ADDENDUM # 2

shinberg
CONSULTING, LLC

F1.00
6/15/09

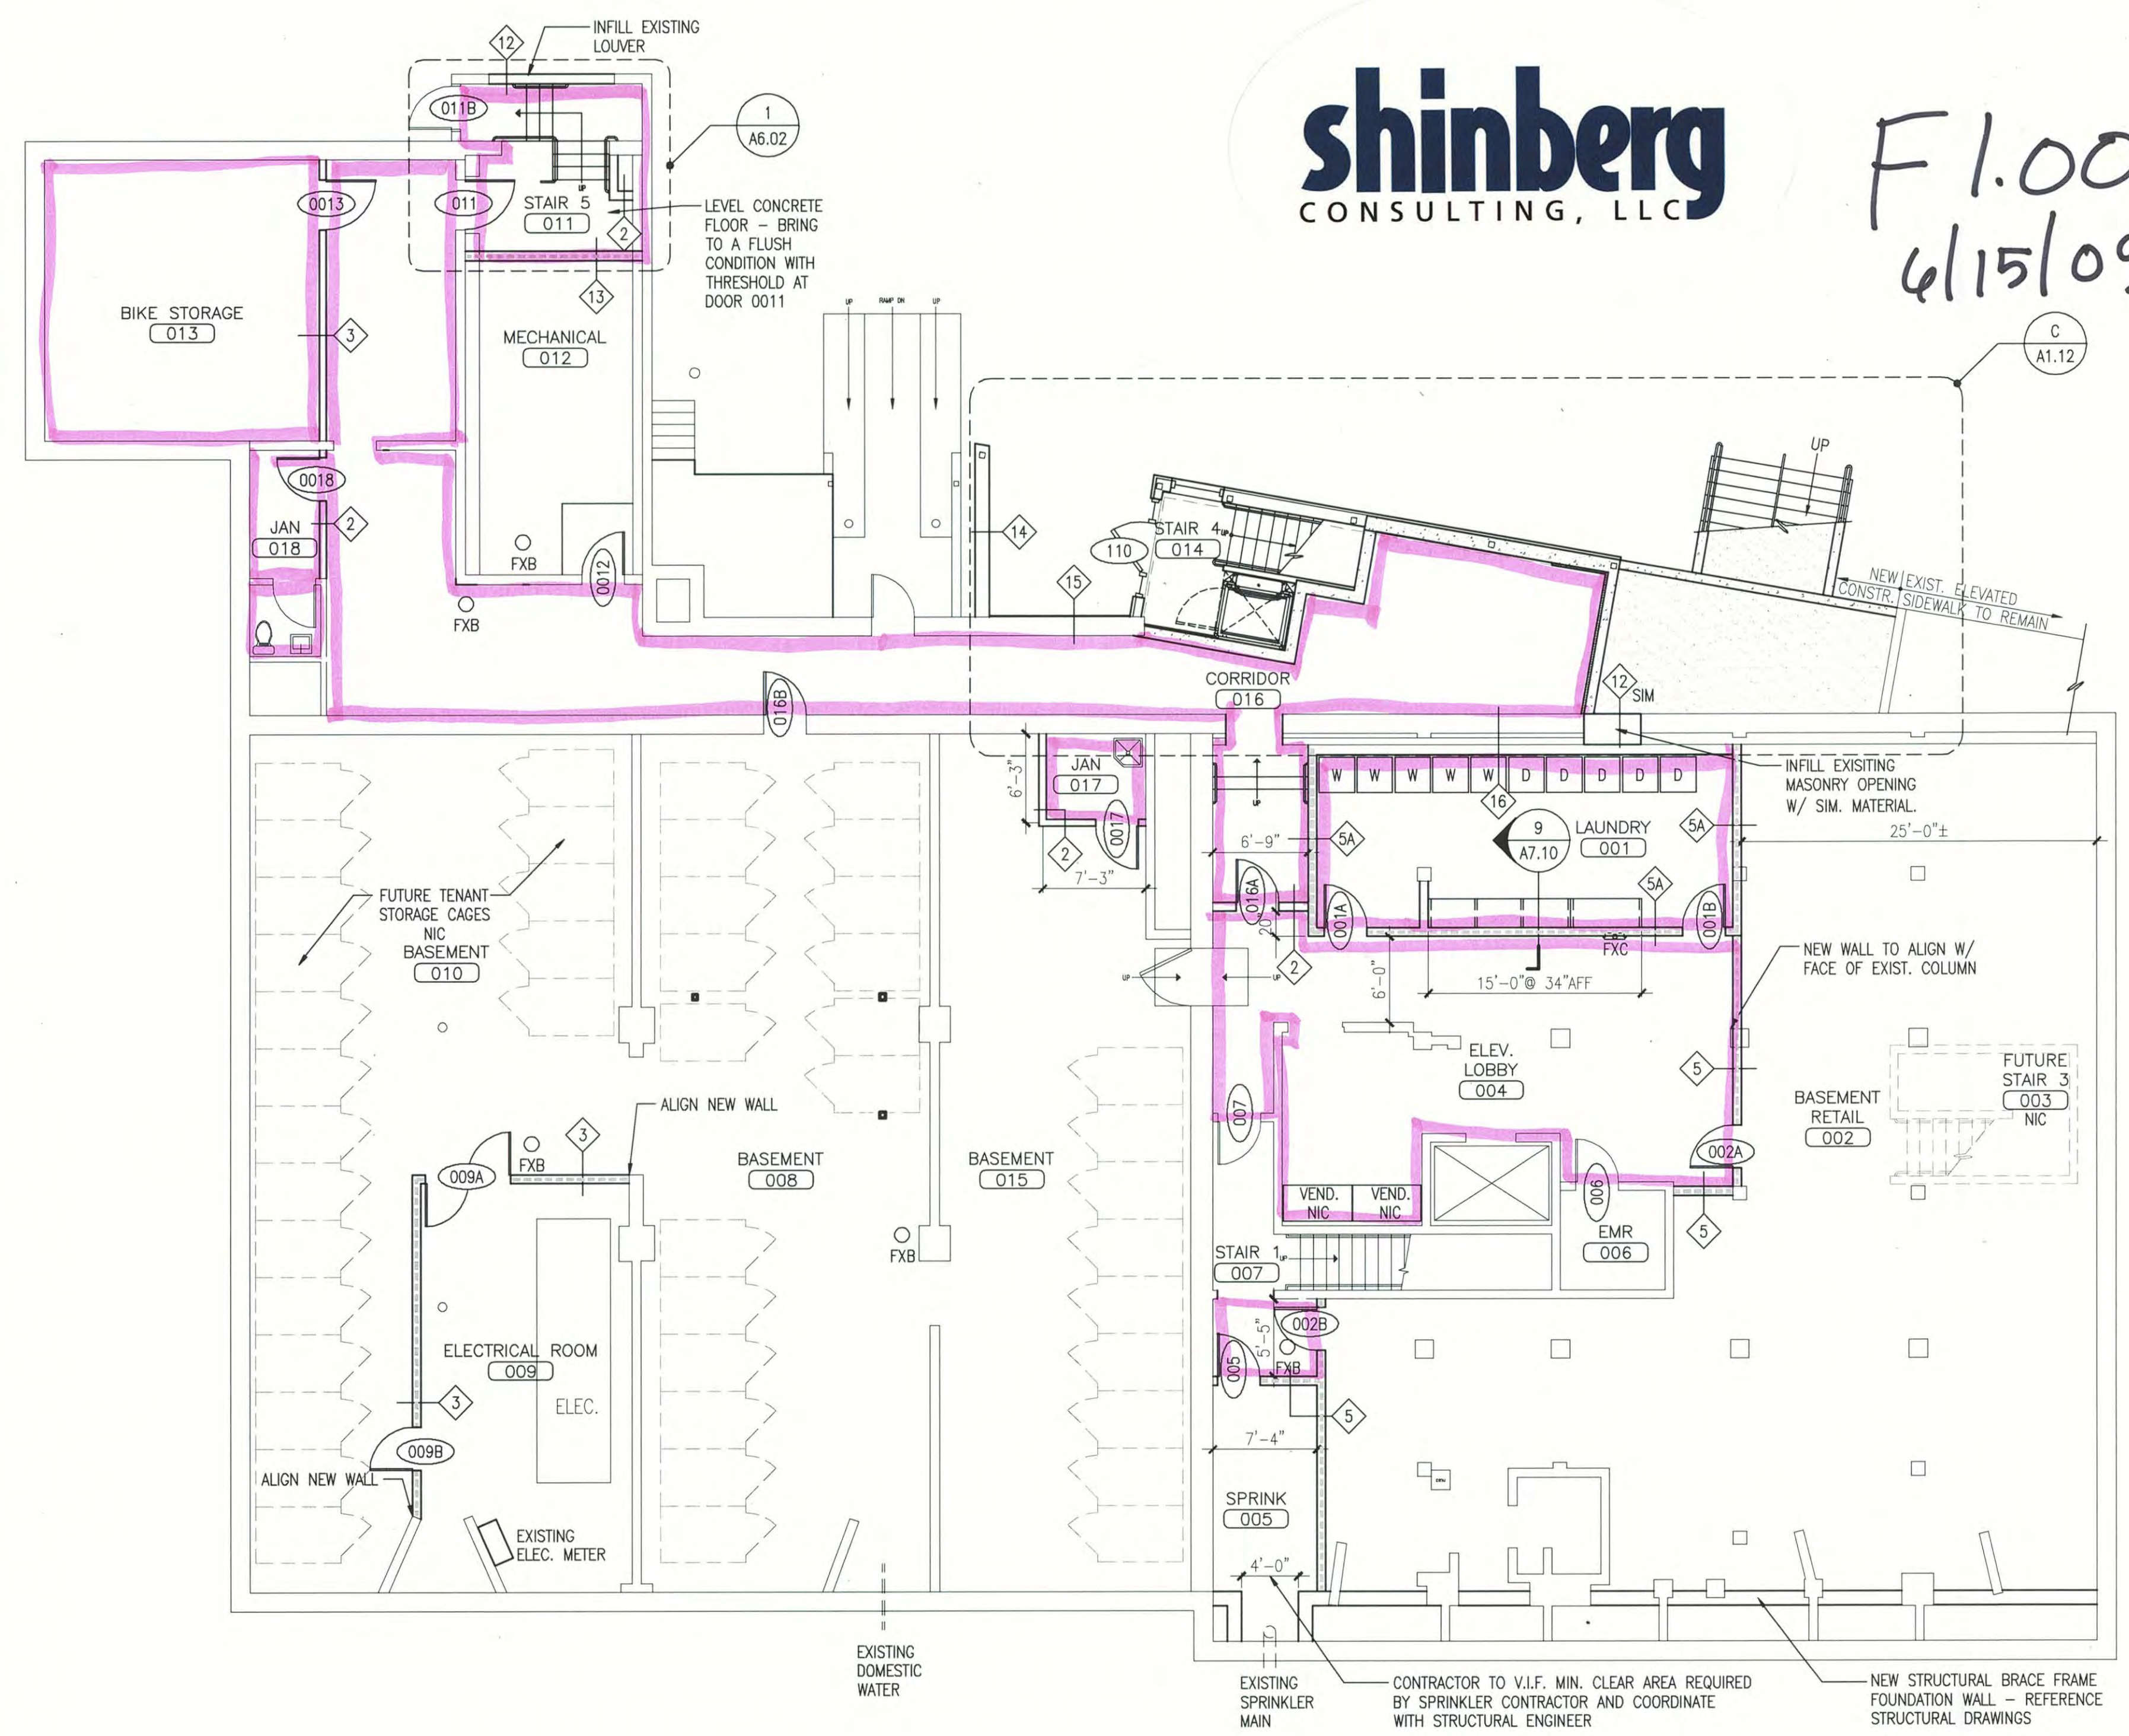
- ORANGE DROP 5/8" DRYWALL CEILING 4" DOWN FROM EXISTING ("CHICAGO STYLE")
- BLUE INSTALL 5/8" DRYWALL DIRECTLY TO EXISTING CEILING
- GREEN INSTALL 2'x2' ACT TO BE ARMSTRONG #1775 DUNE (OR EQUAL) CLIMAPLUS CIRrus w/ 9/16" SUPRAFINE GRID
- PINK INSTALL 2'x4' ACT TO BE ARMSTRONG SQUARE EDGE PANELS CLEAN ROOM VL (OR EQUAL) w/ 1/16" GRID
